Neighbourhood Report-Back

400 Block Clarence Ave
Revised Design Concept

Pedestrian & Cyclist Safety Strategies

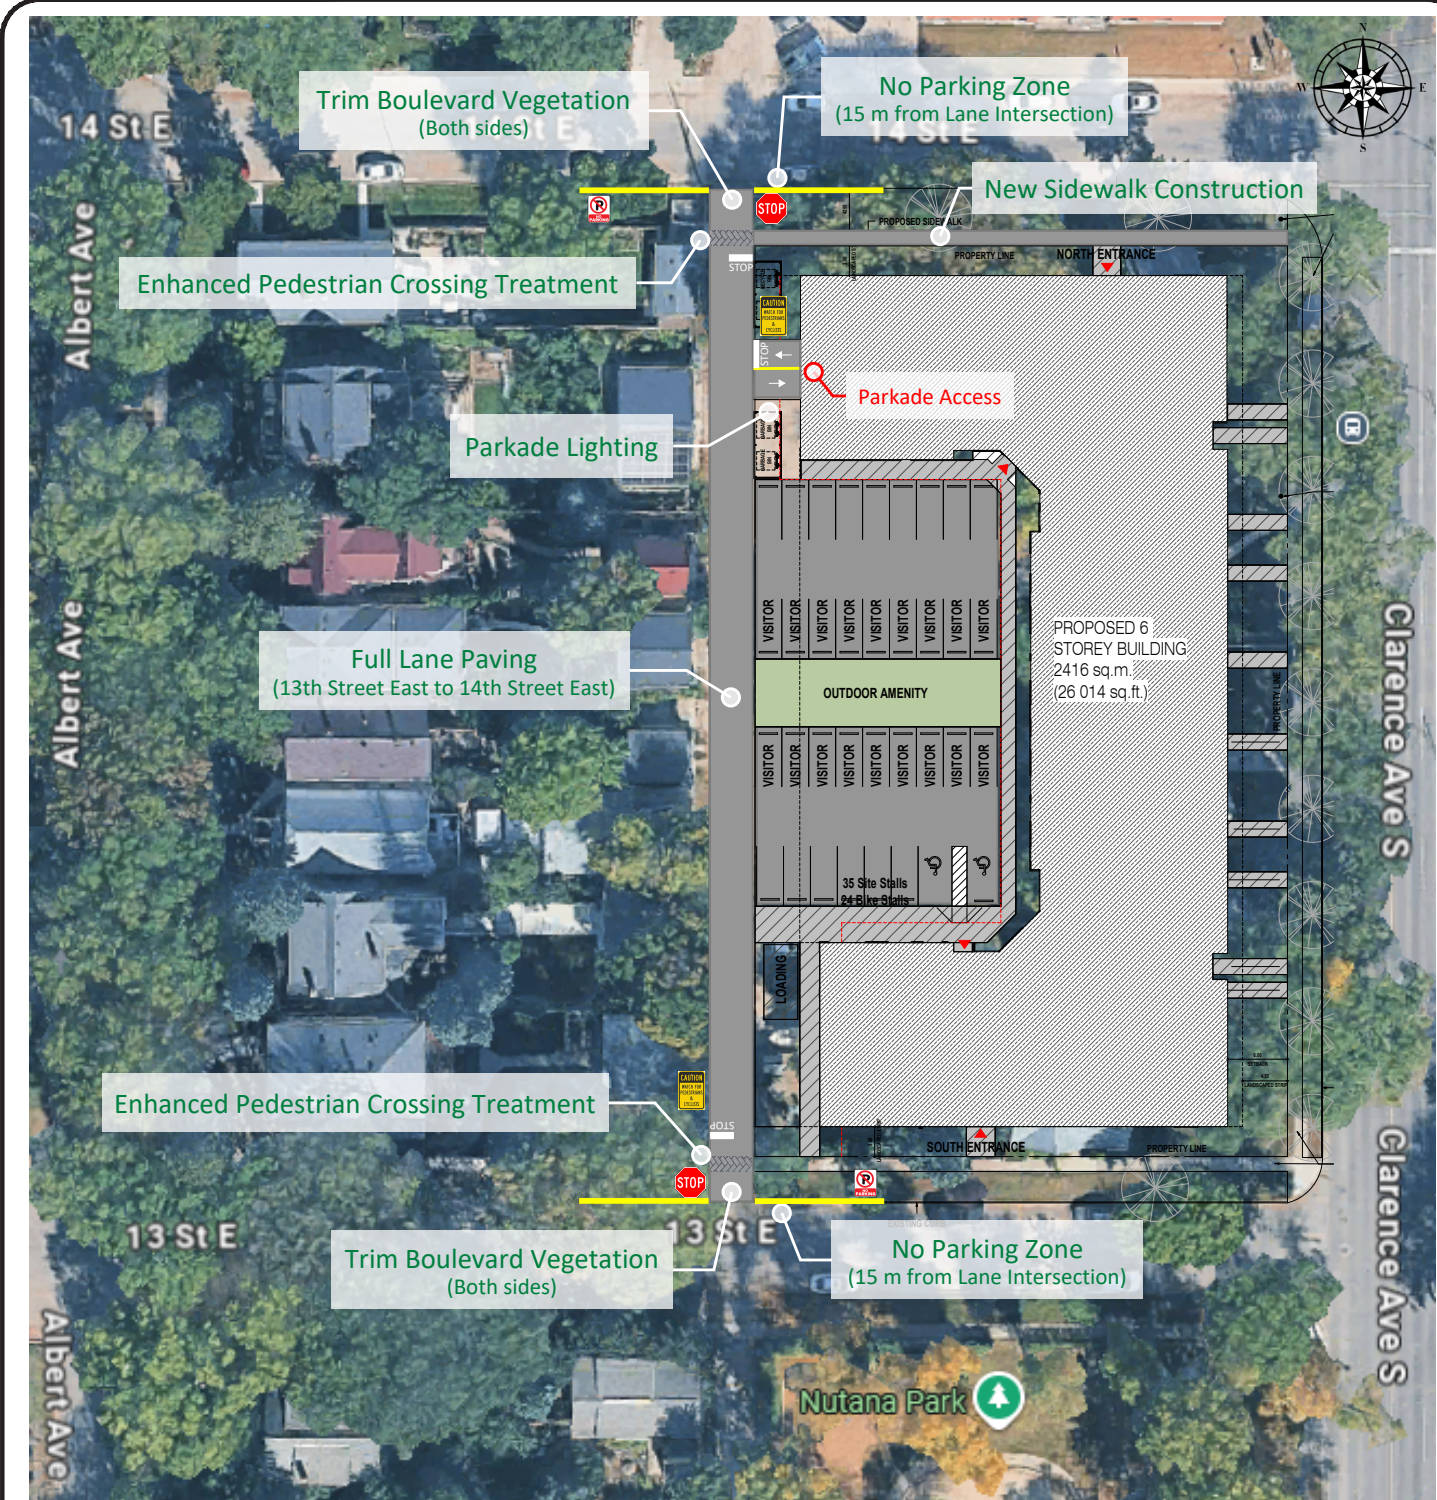
- Concerns around traffic and vehicular movement/access points
- Request for additional study regarding pedestrian safety and active transportation around the site
- Questions around lane functionality and ability to support the use

- Improve sightlines by reducing overgrowth and enhancing lighting
- Stop signs & advance stop bars
- Pedestrian, child at play & cyclist warning signage
- No parking zone on each side of the lane
- High visibility pavement markings at crossing
- Pave lane and new sidewalk construction

NOTE: Mitigation measures shown are conceptual and intended for illustrative purposes only. Final locations, dimensions, traffic control devices, pavement markings, and design details are subject to detailed design and approval by the City of Saskatoon.

Clarence Ave Interface — Concept Sketch

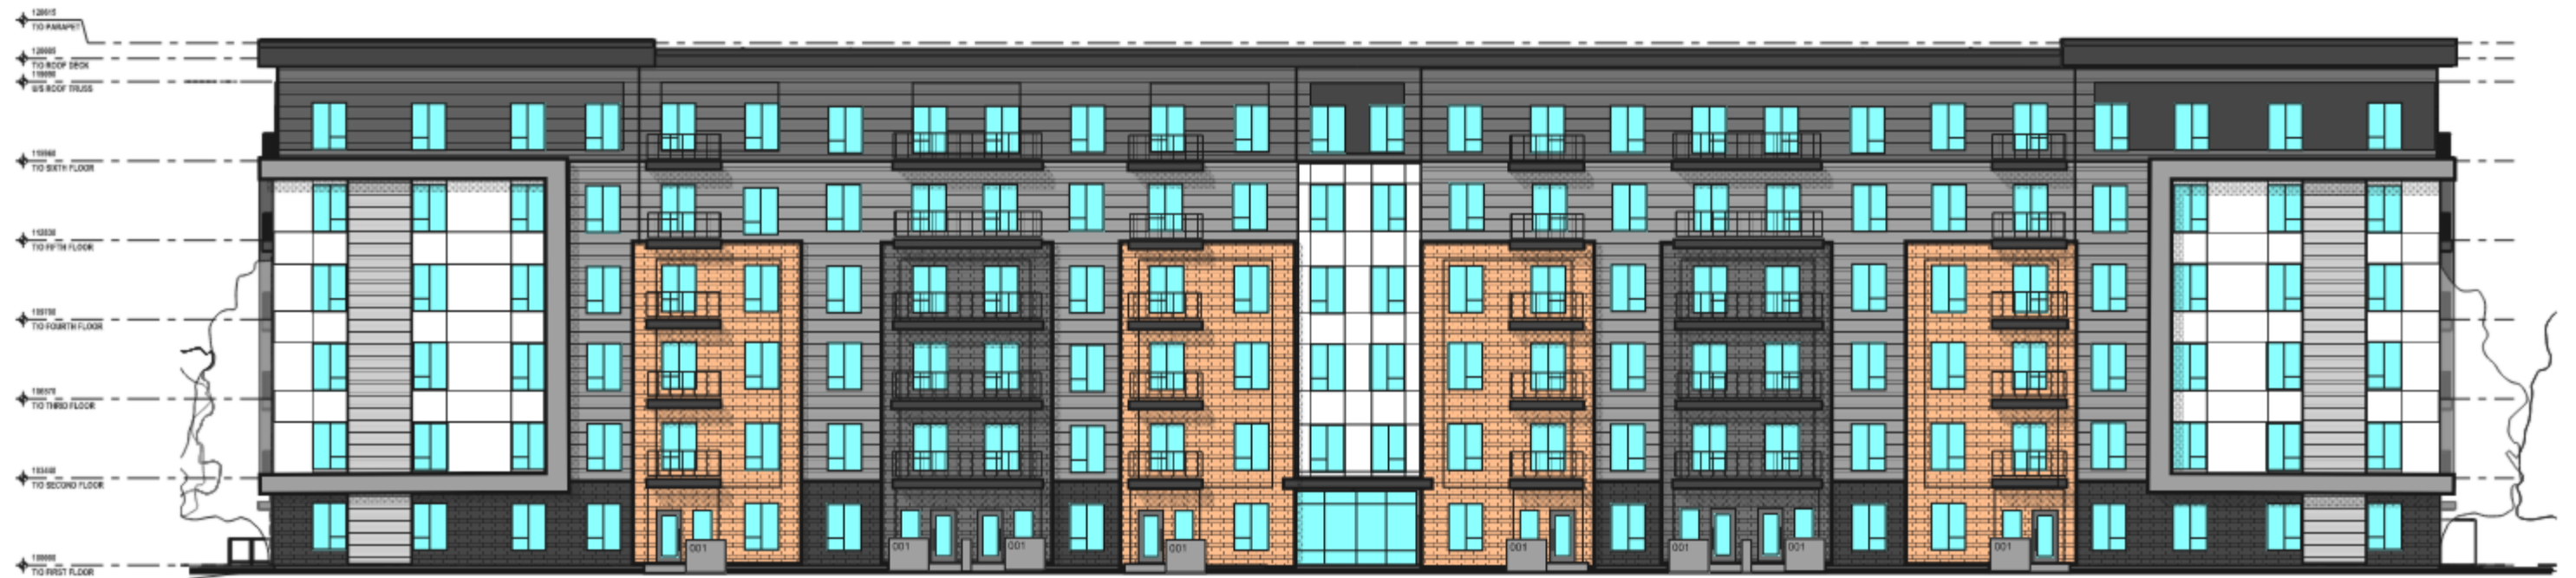
- Building feels too large and uniform.
- Desire for design to reflect the scale and character of the neighbourhood.
- Would like pedestrian-scale elements and a more residential expression.

Reduce prominence of the corner building cap

Four-storey articulation to reinforce pedestrian scale

Ground-oriented townhomes to activate the Clarence Ave frontage

Laneway Interface — Reduced Overlook & Added Amenity

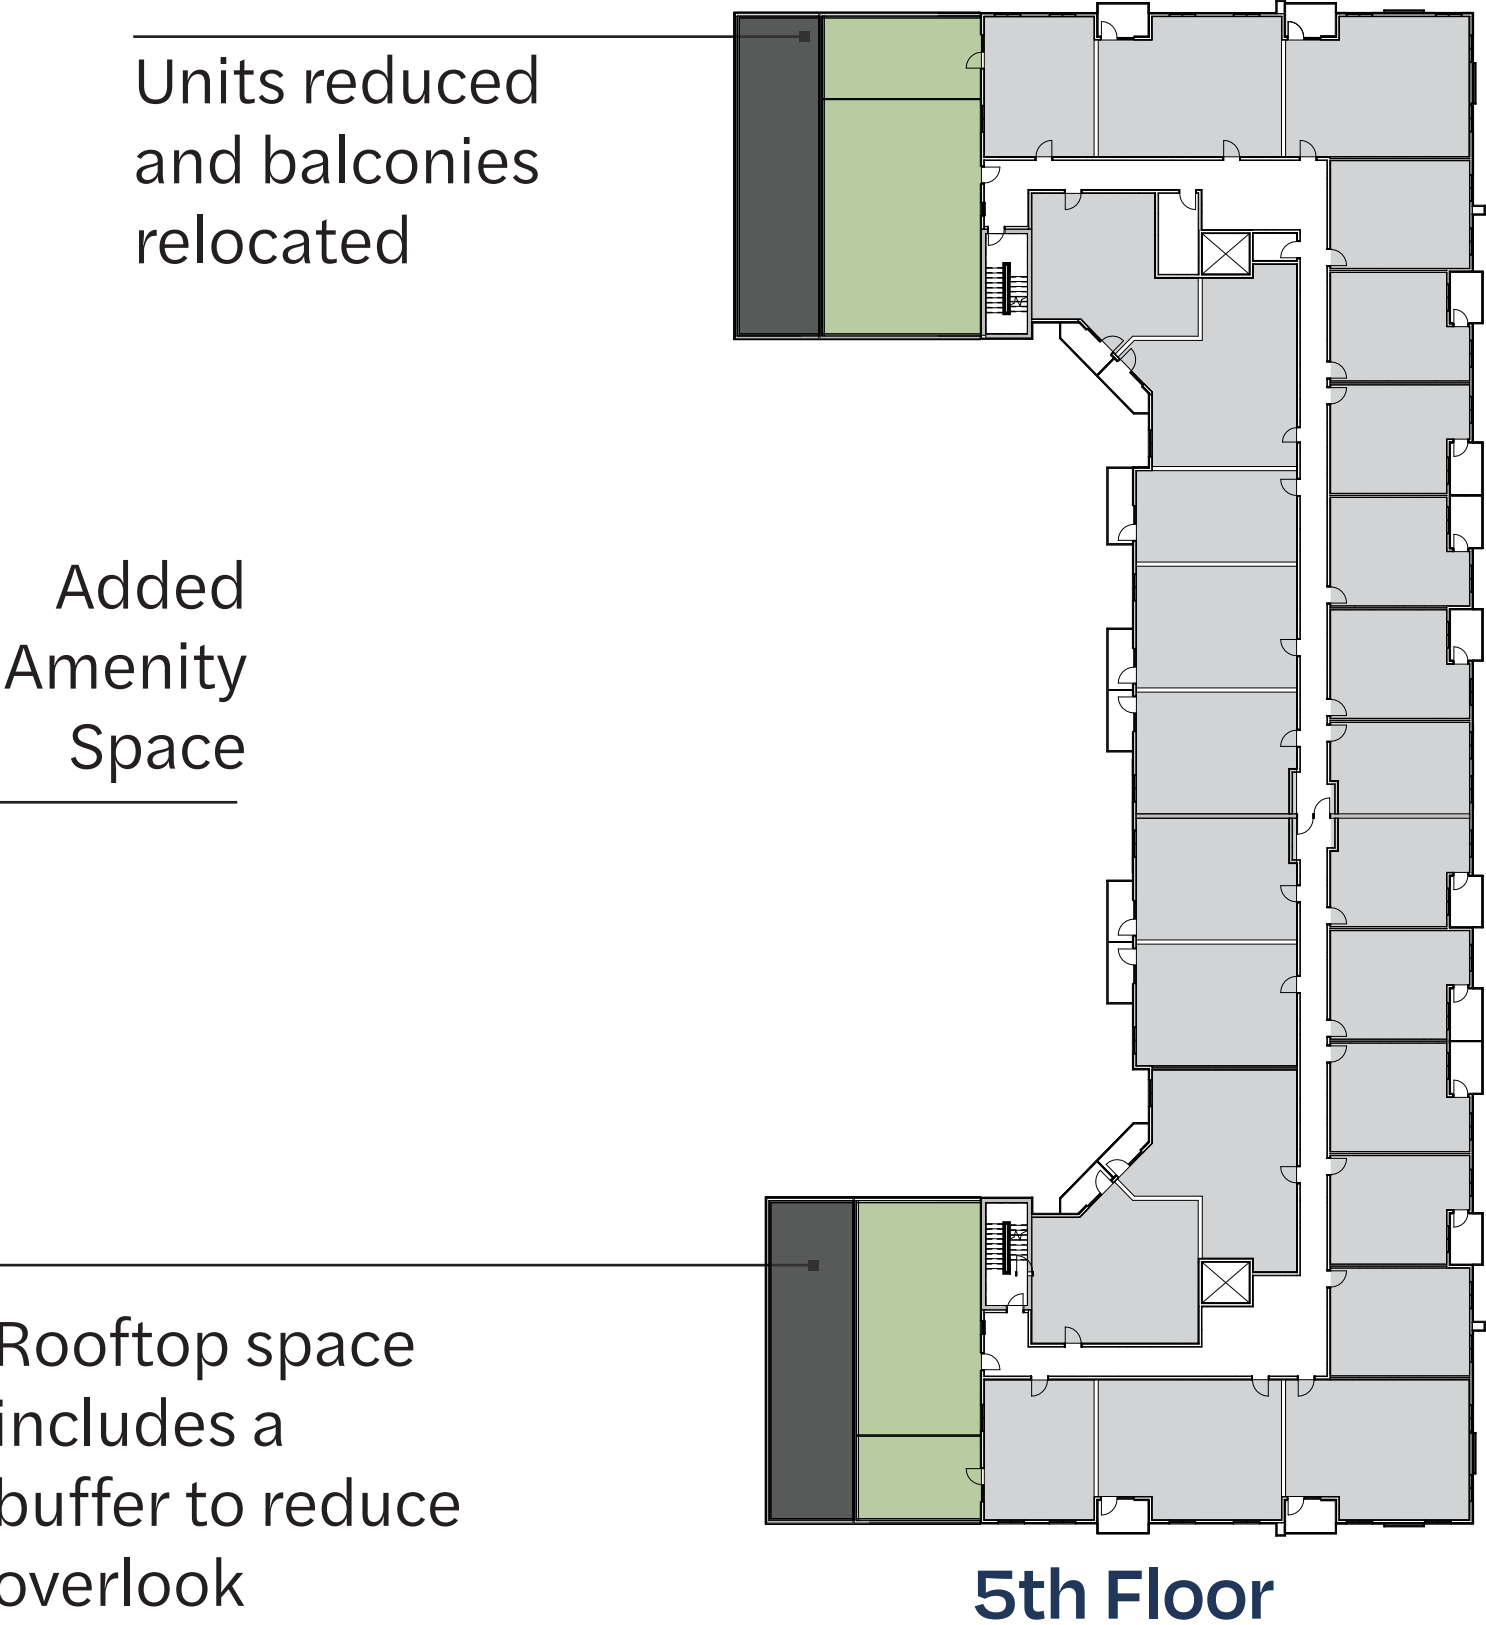
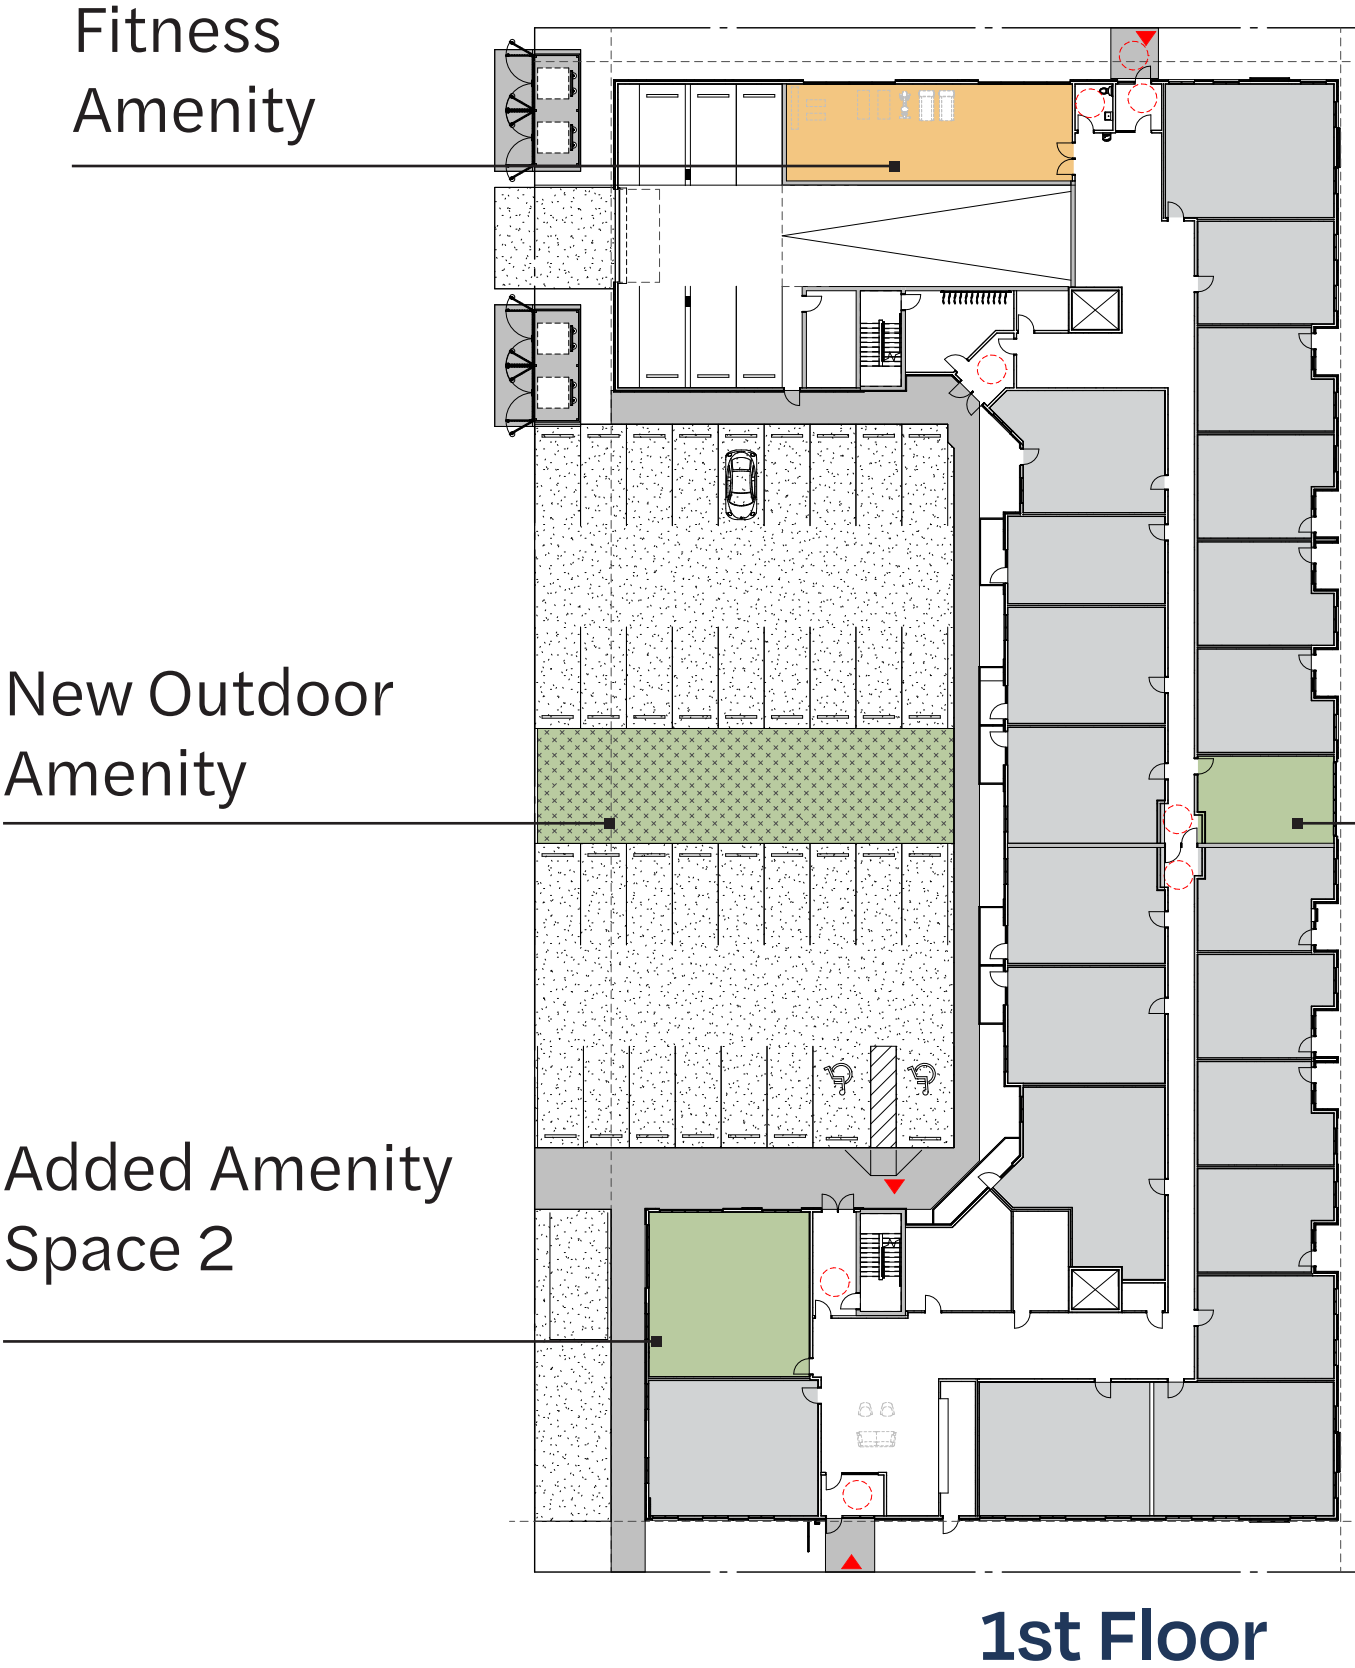
- Concerns about overlook from balconies
- Would like mitigations for privacy
- Limited amenity space on property

- Unit reduction on North and South
- Building stepback to reduce overlook
- Additional interior and exterior amenity space
- Landscaping and buffering

Summer Solstice — Highest Sun Angle

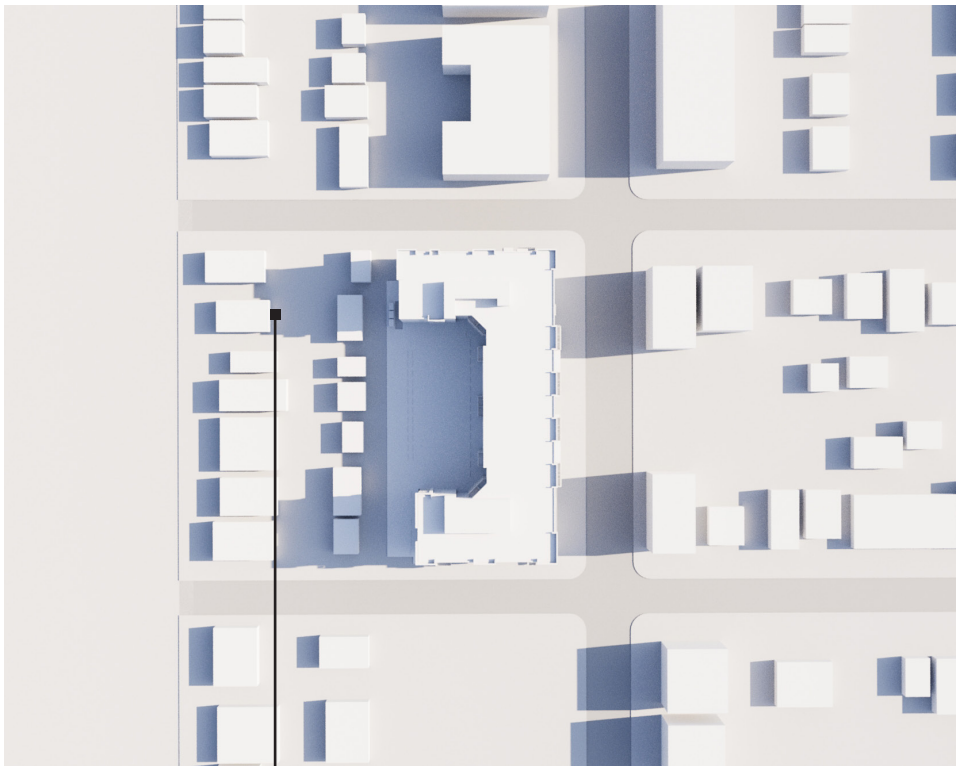
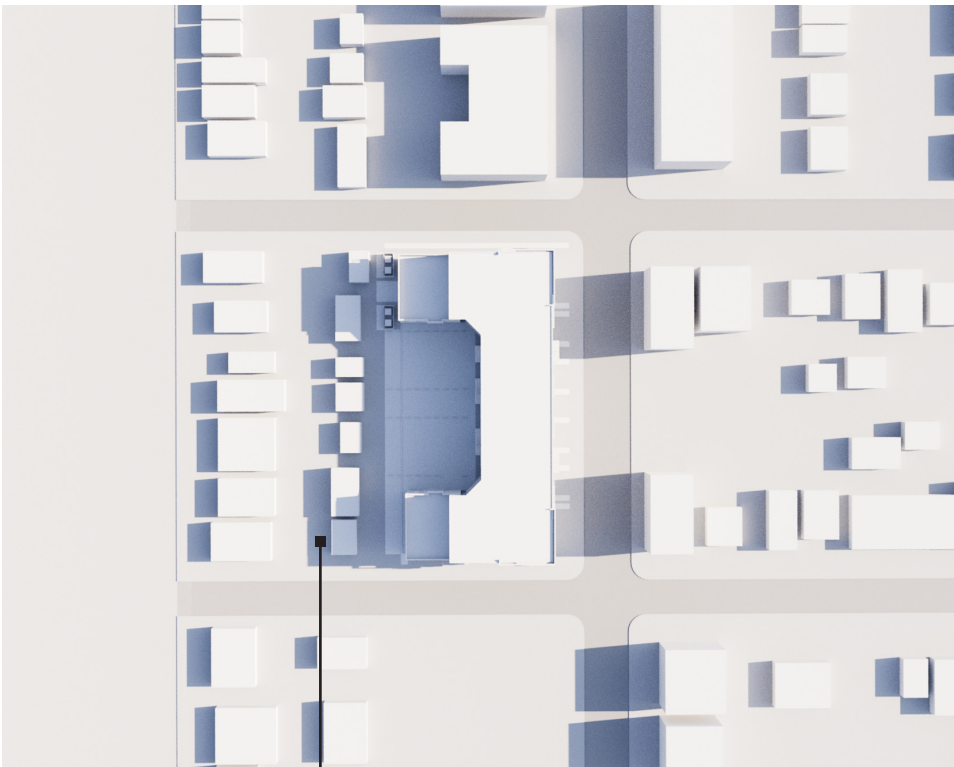
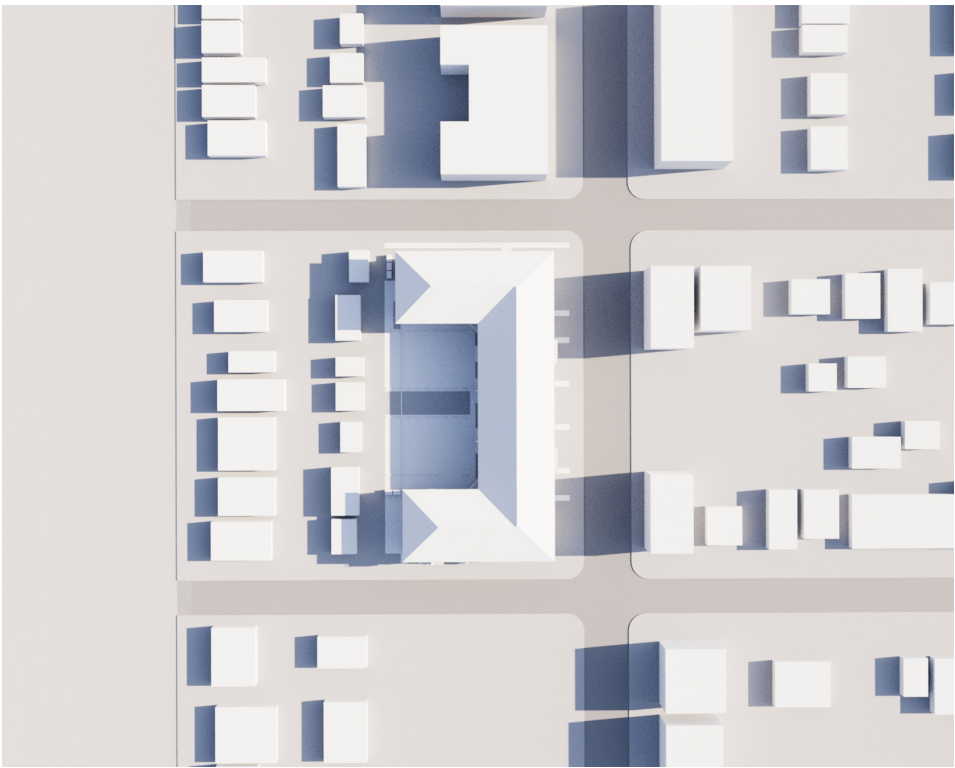
- Neighbours requested a clearer understanding of shadow impacts
- Yards facing the lane were of particular interest
- Concerns around rooftop solar PV performance

Finding: Shadows are reduced from original at 8am

Shadow extends
past site into yard

Shadow impact
reduced
